## **Accessibility Report**

### **New Primary School in Googong Gorman Drive, Googong, NSW**

**Report No:** GOOG-DD-SSDA-RPT-0002  
**Revision:** A  
**Date:** 14 May 2021

**NEW PRIMARY SCHOOL IN GOOGONG**  
GORMAN DRIVE, GOOGONG NSW 2620  
DRAWING NAME  
**BUILDING B - GROUND FLOOR - FURNITURE PLAN**

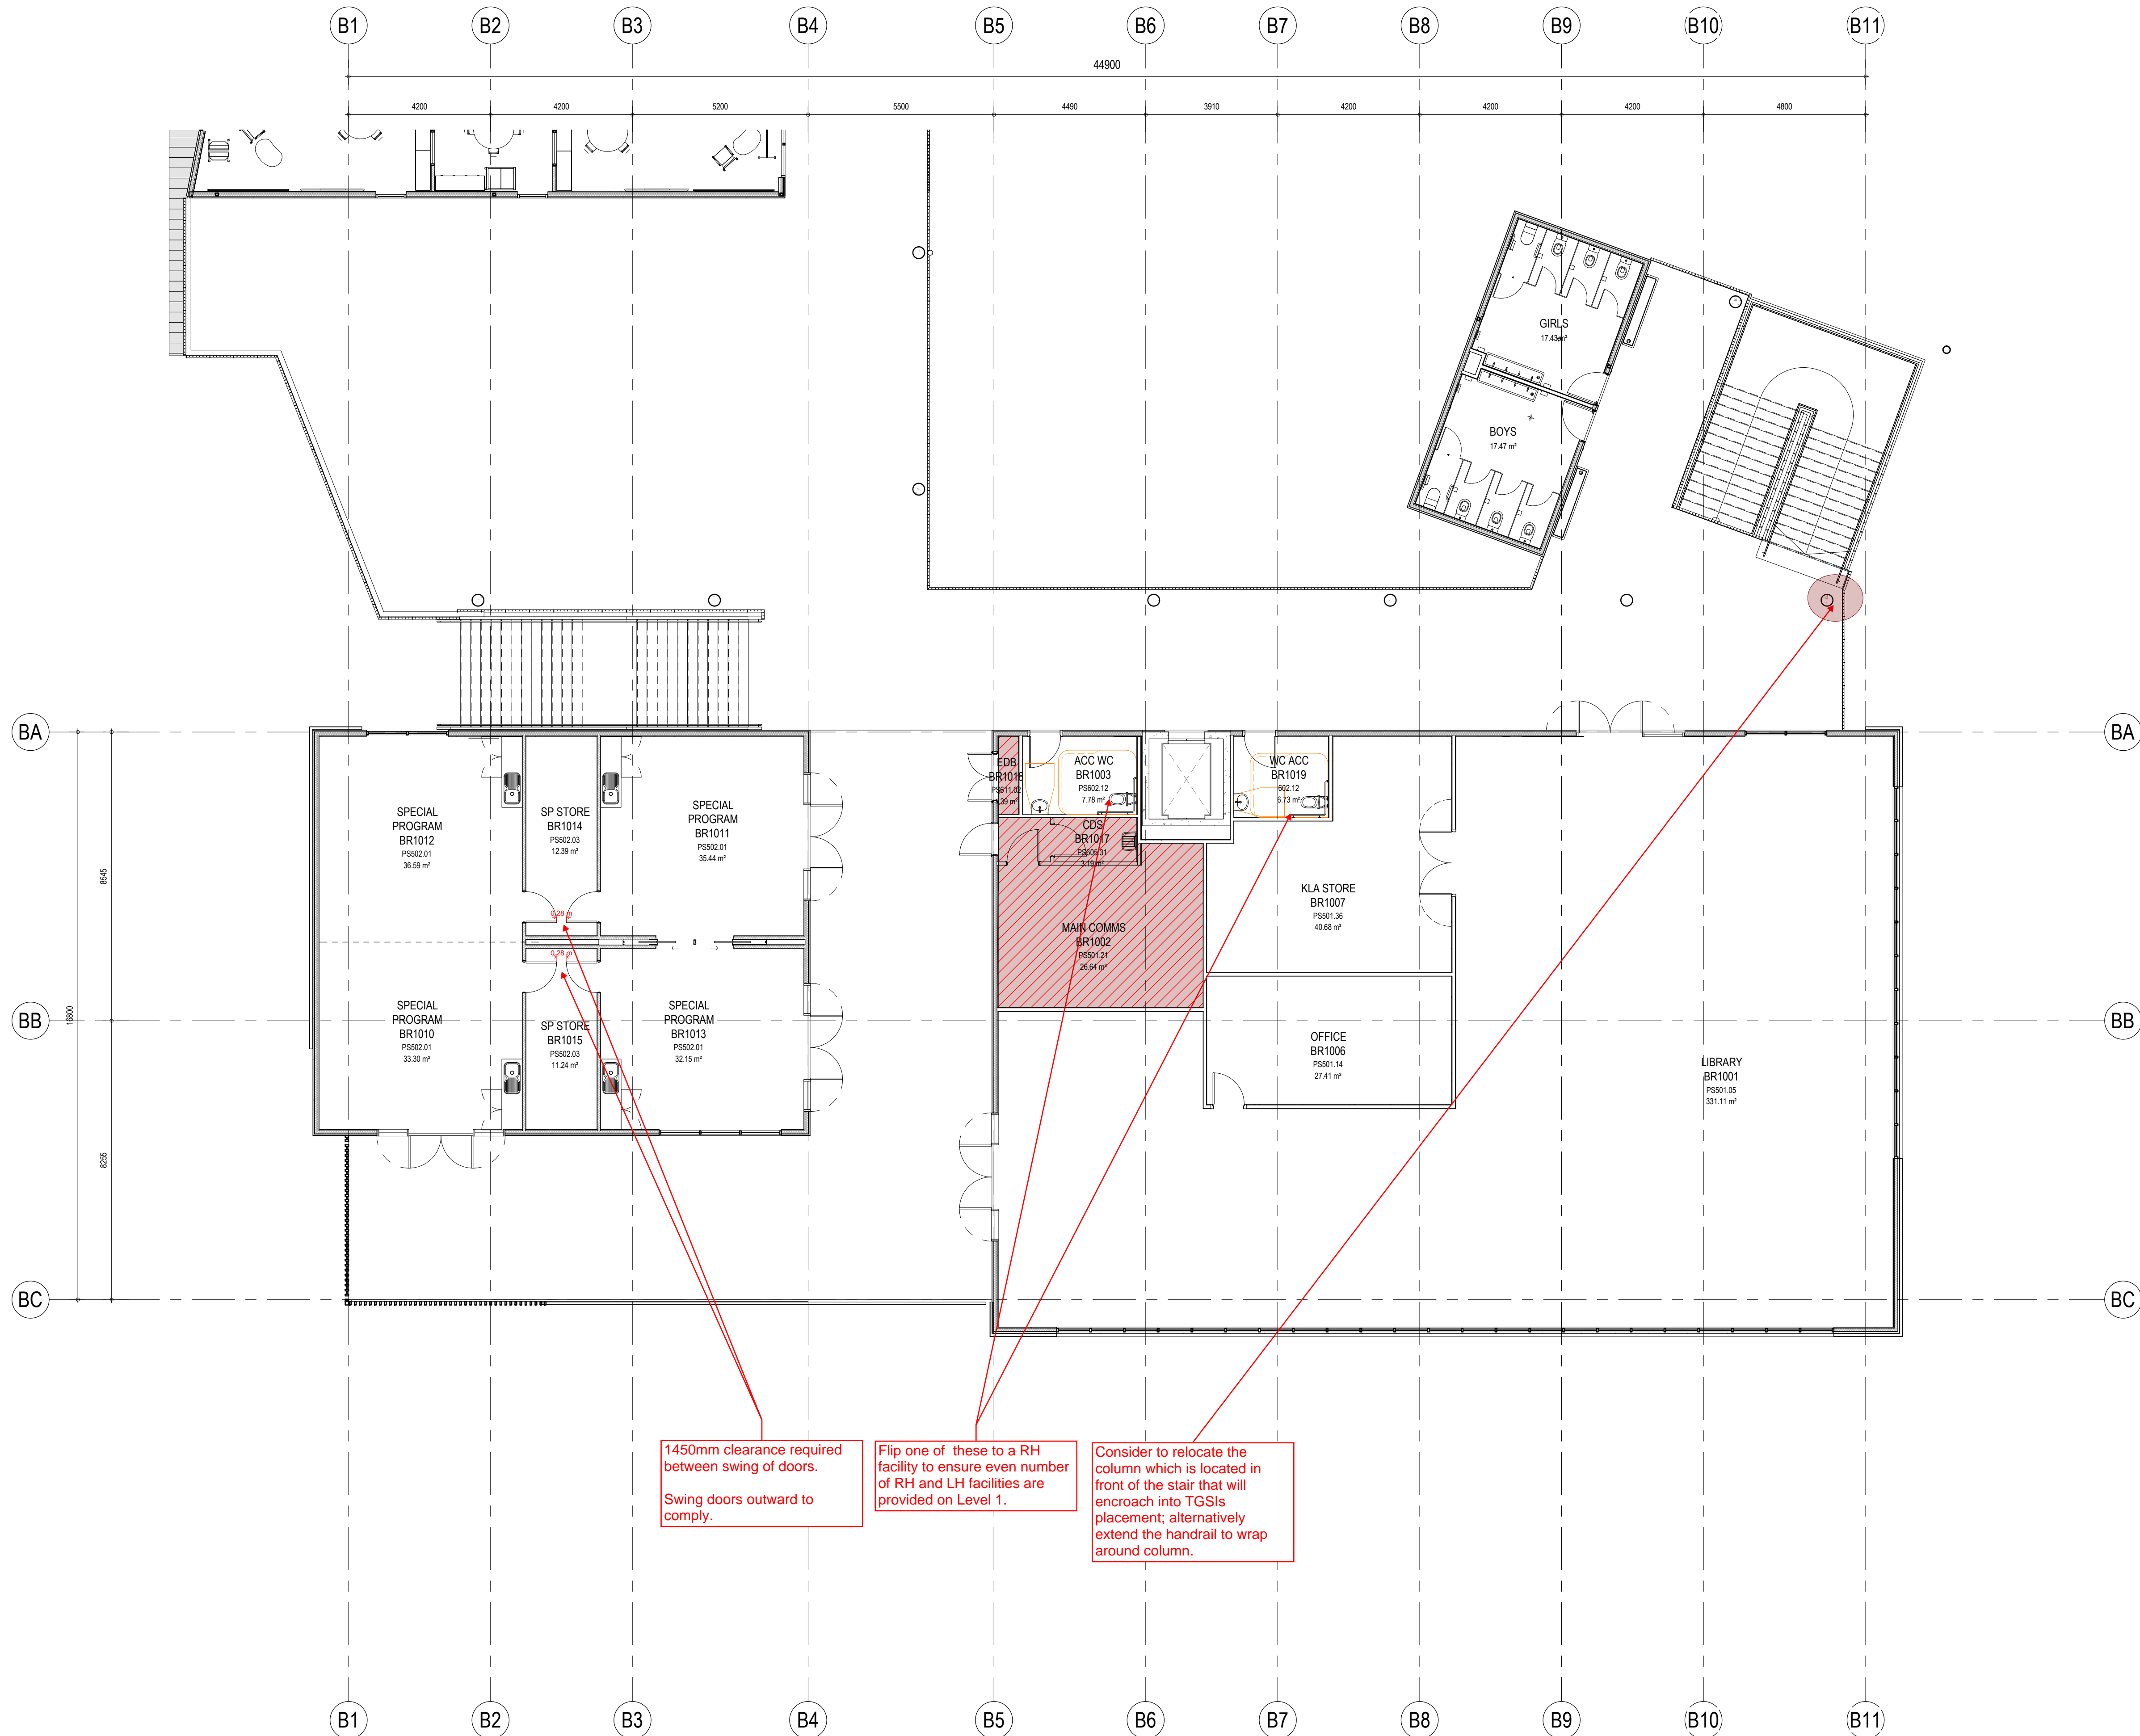
Areas that may be applicable for exemption from disability access under BCA Clause D3.4, provided Client can verify use and users of these areas.

**NEW PRIMARY SCHOOL IN GOOGONG**  
GORMAN DRIVE, GOOGONG NSW 2620  
DRAWING NAME  
**BUILDING B - FIRST FLOOR - FURNITURE PLAN**

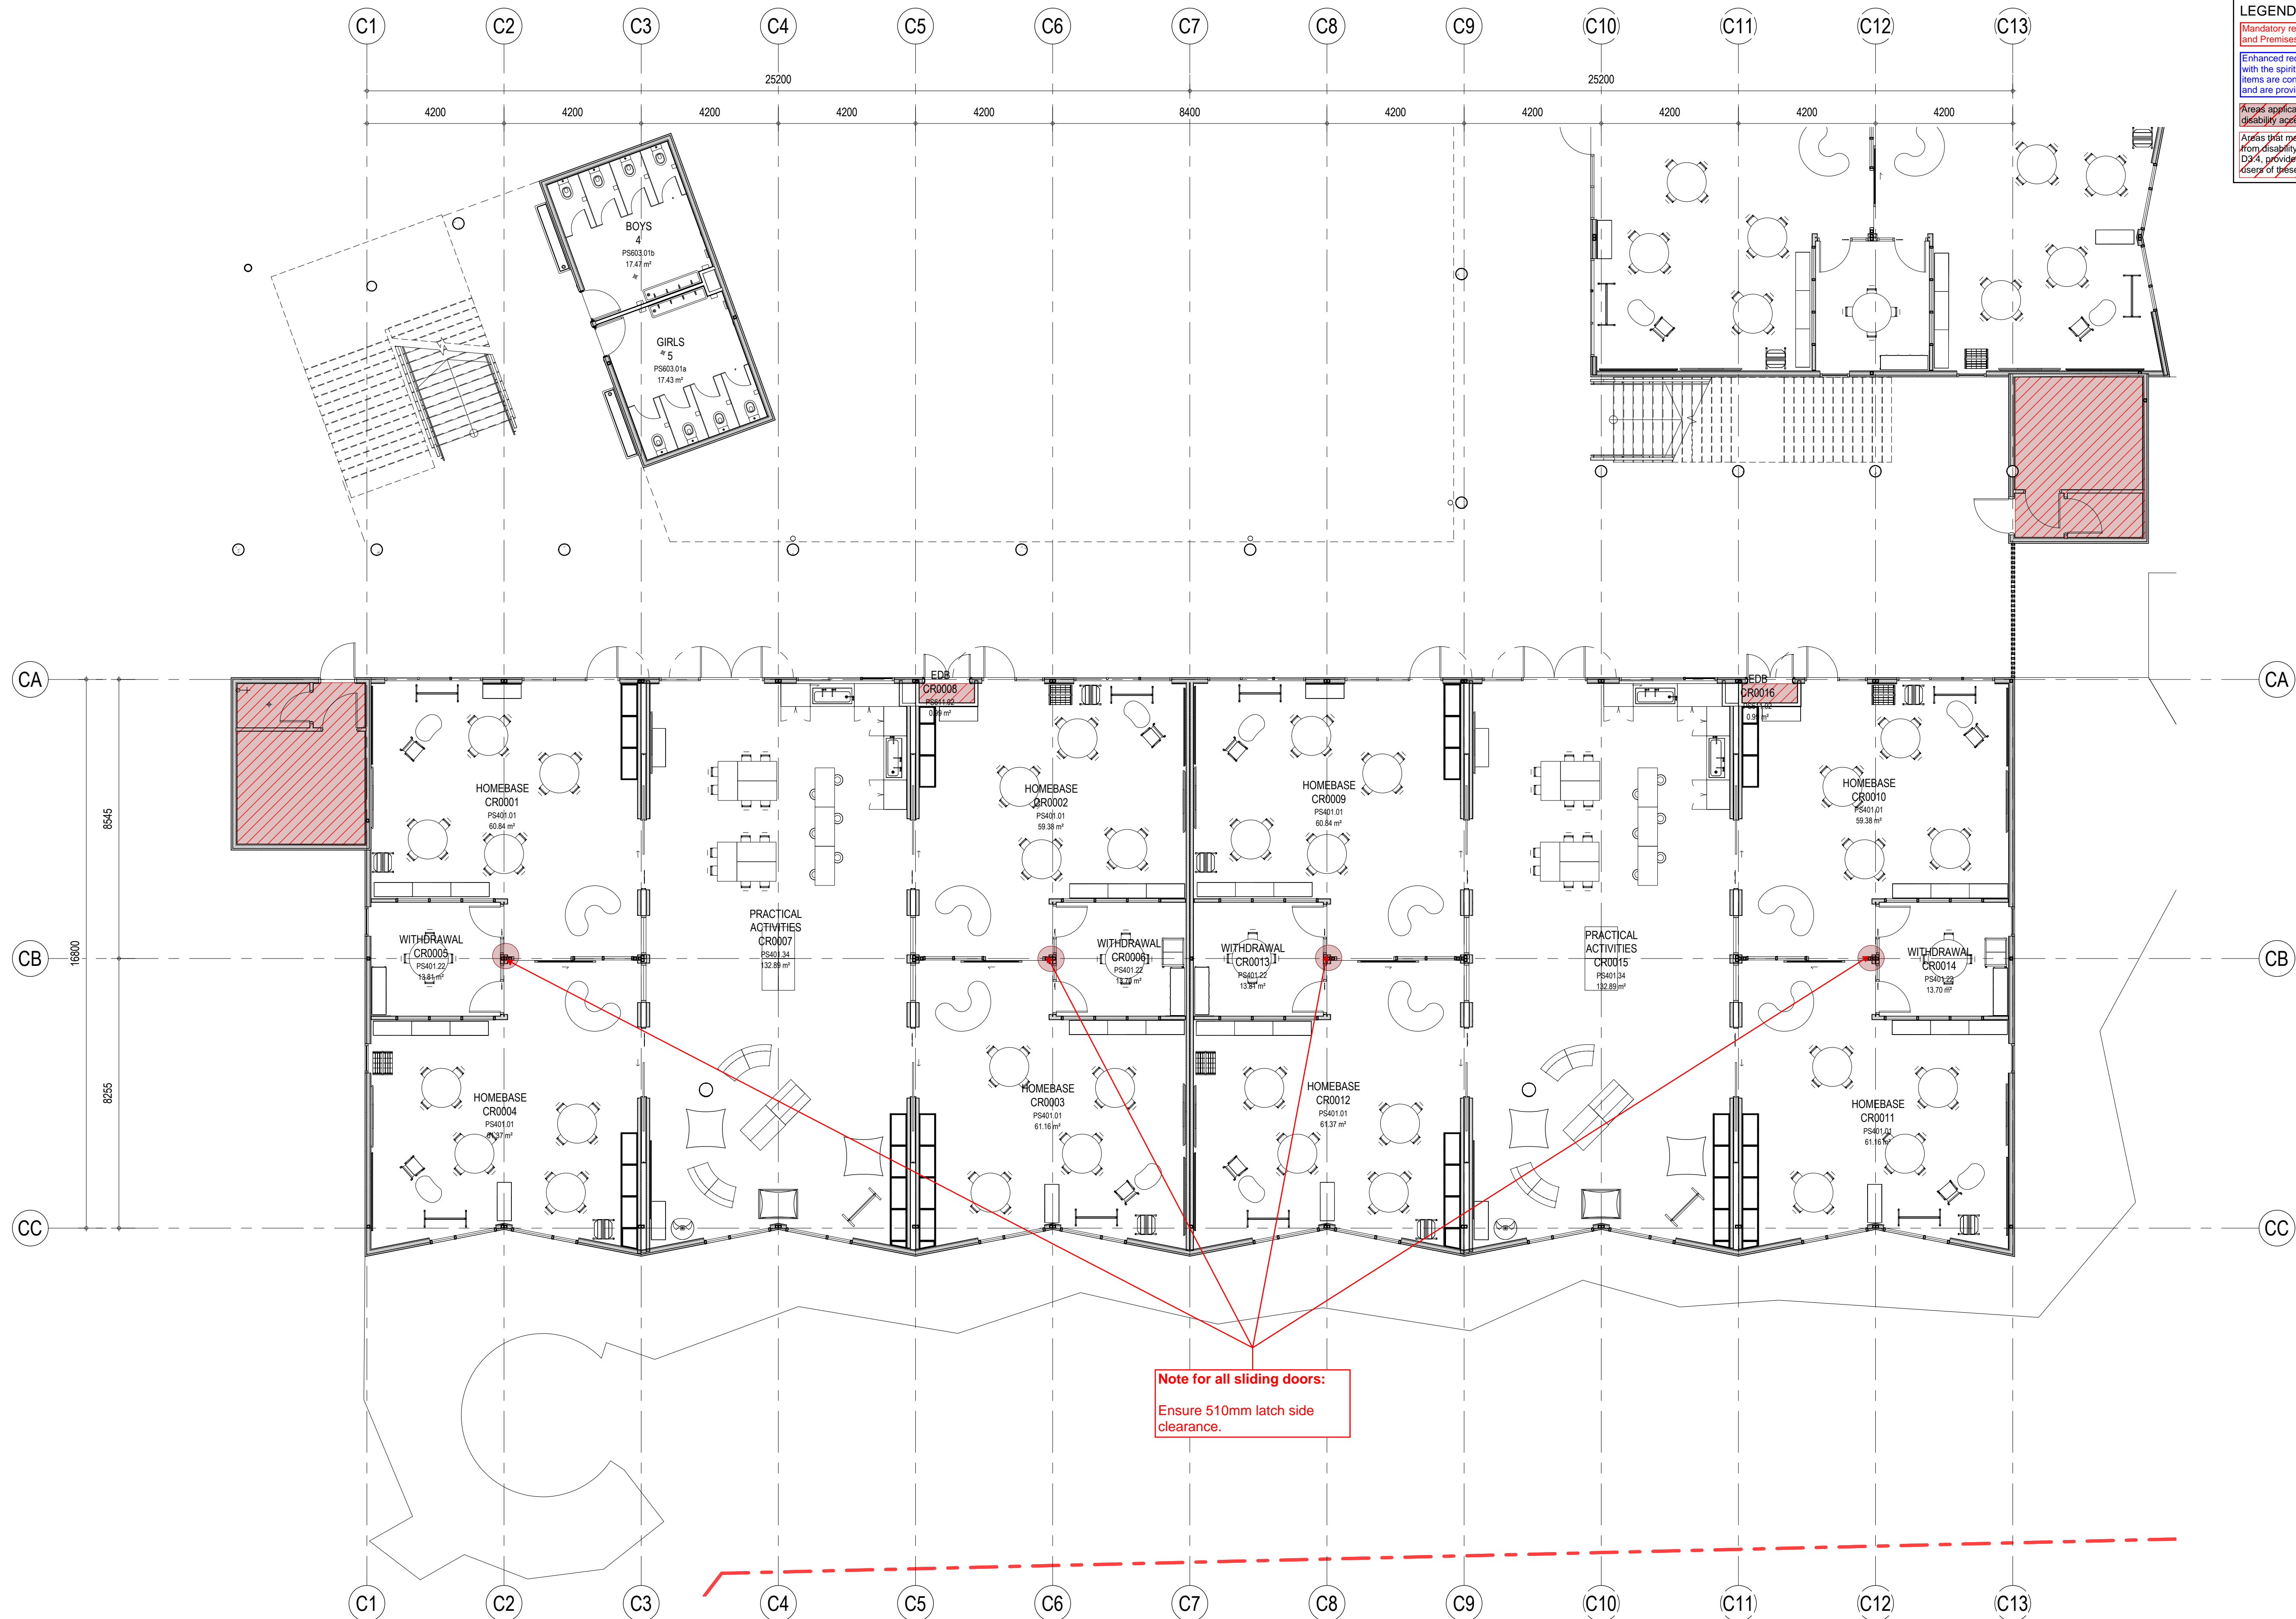
Areas that may be applicable for exemption from disability access under BCA Clause D3.4, provided Client can verify use and users of these areas.

BUILDING C - GROUND FLOOR - FURNITURE PLAN

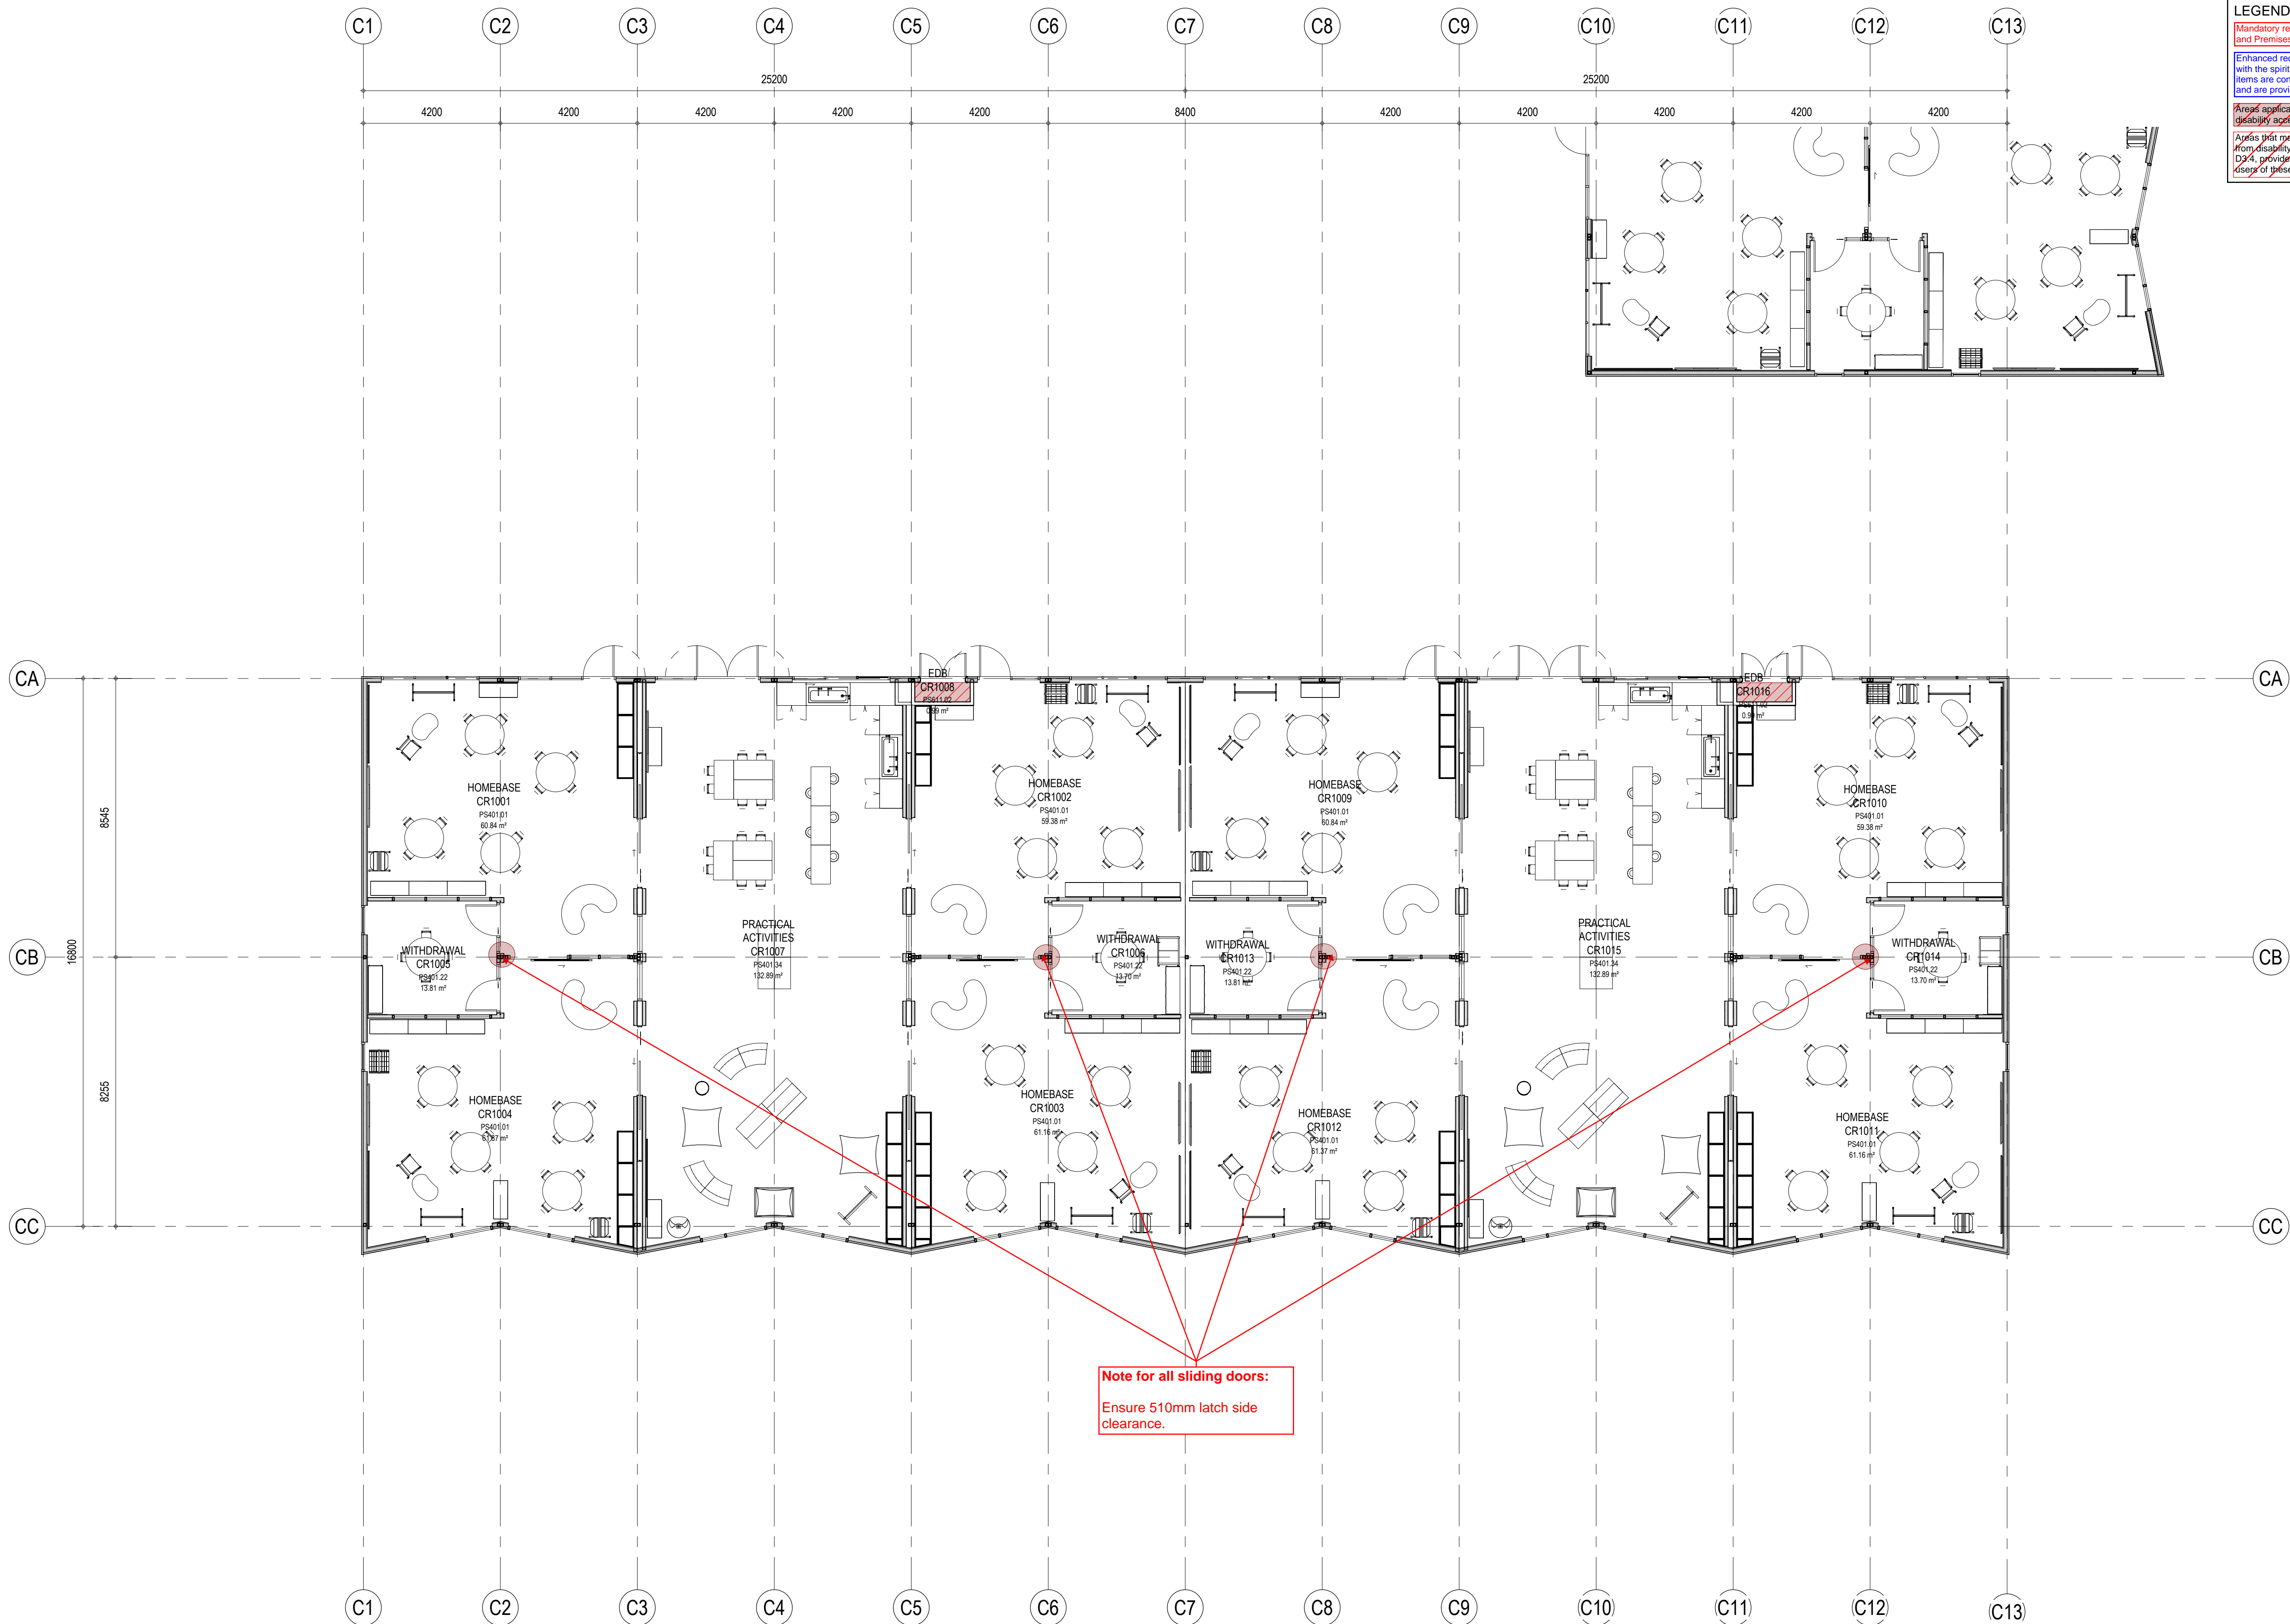
Areas that may be applicable for exemption from disability access under BCA Clause D3.4, provided Client can verify use and users of these areas.
